MEMO

To: Kristopher Byrd, Well Construction and Compliance Section Manager
From: Travis Kelly, Well Construction Program Coordinator
Subject: Review of Water Right Application G-19023
Date: August 3, 2021

Groundwater Application Review Summary Form

Application # G- 19023

Figure 4. Stream Depletion for the well closest to surface water; most conservative stream depletion estimate is less than 25% at 30 days.

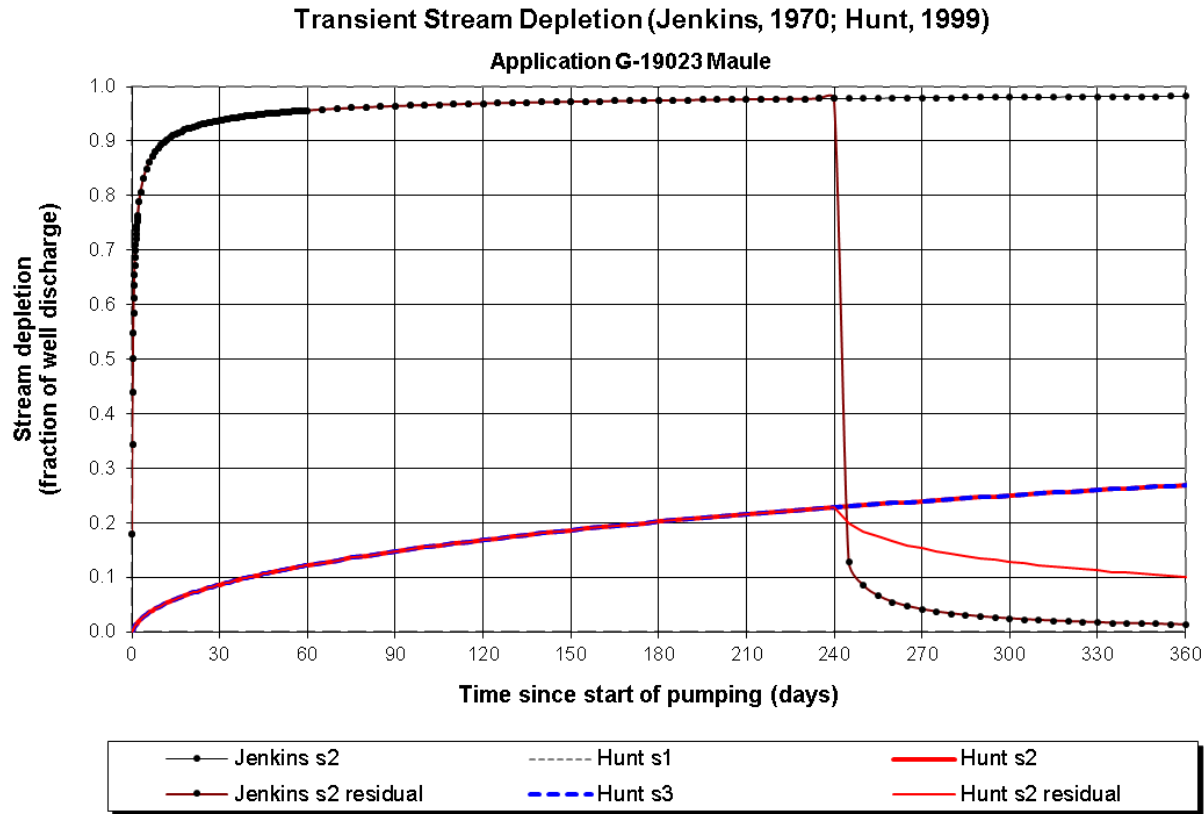
C3a. 690-09-040 (4): Evaluation of stream impacts for each well that has been determined or assumed to be **hydraulically connected and less than 1 mile** from a surface water (SW) source. Limit evaluation to instream rights and minimum stream flows that are pertinent to that SW source, not lower SW sources to which the stream under evaluation is tributary. Compare the requested rate against the 1% of 80% *natural* flow for the pertinent Water Availability Basin (WAB). If Q is not distributed by well, use full rate for each well. Any checked box indicates the well is assumed to have the potential to cause PSI.

Well	SW #	Well < ¼ mile?	Qw > 5 cfs?	Instream Water Right ID	Instream Water Right Q (cfs)	Qw > 1% ISWR?	80% Natural Flow (cfs)	Qw > 1% of 80% Natural Flow?	Interference @ 30 days (%)	Potential for Subst. Interfer. Assumed?
1	1	<input checked="" type="checkbox"/>	<input type="checkbox"/>	n/a	n/a	<input type="checkbox"/>	3620	<input type="checkbox"/>	<25%	<input checked="" type="checkbox"/>
2	1	<input checked="" type="checkbox"/>	<input type="checkbox"/>	n/a	n/a	<input type="checkbox"/>	3620	<input type="checkbox"/>	<25%	<input checked="" type="checkbox"/>
3	1	<input checked="" type="checkbox"/>	<input type="checkbox"/>	n/a	n/a	<input type="checkbox"/>	3620	<input type="checkbox"/>	<25%	<input checked="" type="checkbox"/>
4	1	<input checked="" type="checkbox"/>	<input type="checkbox"/>	n/a	n/a	<input type="checkbox"/>	3620	<input type="checkbox"/>	<25%	<input checked="" type="checkbox"/>

Figure 5. Well interference estimate between proposed well 1 and POLK 300, located on the adjacent taxlot

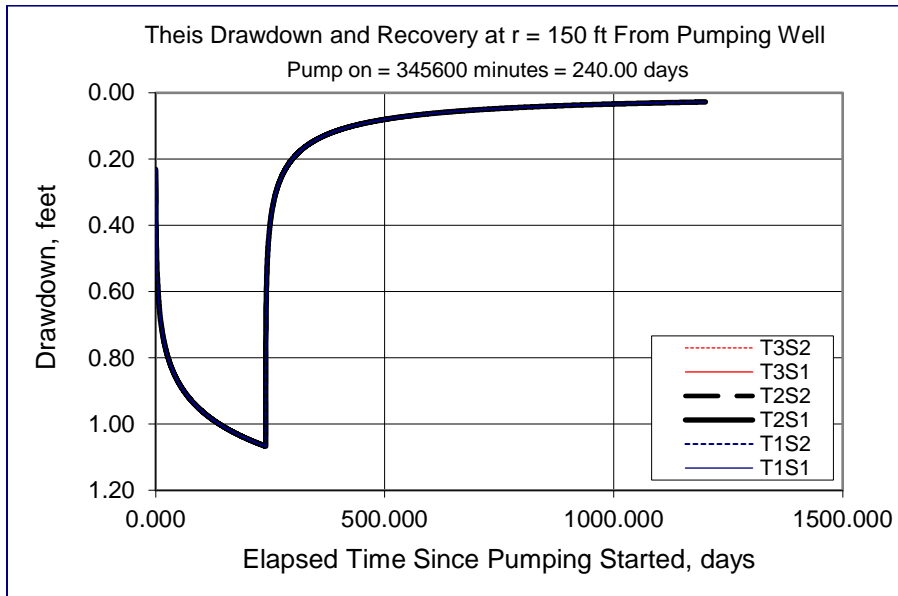
The proposed wells are all in close proximity to POLK 300, a well located on the adjacent taxlot. Drawdown from proposed pumping at Well 1, located approximately 150 feet northwest of POLK 300, is estimated between 1 and 2 feet after 240 days of pumping at the maximum requested rate (see Figure 5). POLK 300 is 46 feet deep with 34 feet of water during the annual high per the well log. An additional 2 feet of drawdown will not prevent access to the usual rates and volumes of groundwater.
